## Product Change Notification

### PCN-ICC-1457-2018

Business Unit	Product Line Code	Type of Change	Action	Date of Issue
ICC - Industrial Cabinet	BE2	Product Change Notification	Notify Distributors and Field	3/23/2018

#### Description for Product Change Notification

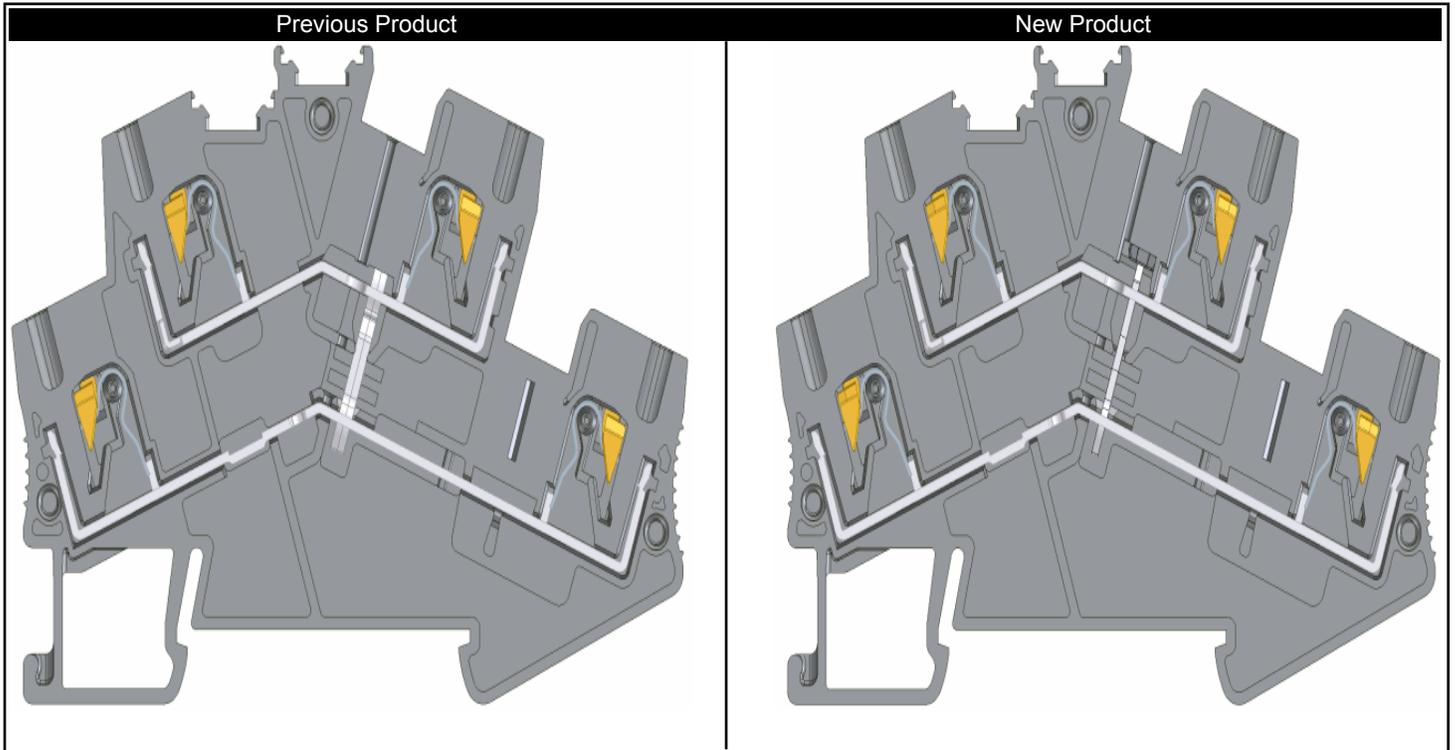
Improved PV metal for easier and faster installation. Thus, an automated production would be possible in the future. Based on laboratory testing, the conclusion has been made that one piece of metal meets all requirements, thus eliminating the need for a second piece. The change has no influence on the electrical data or approvals.
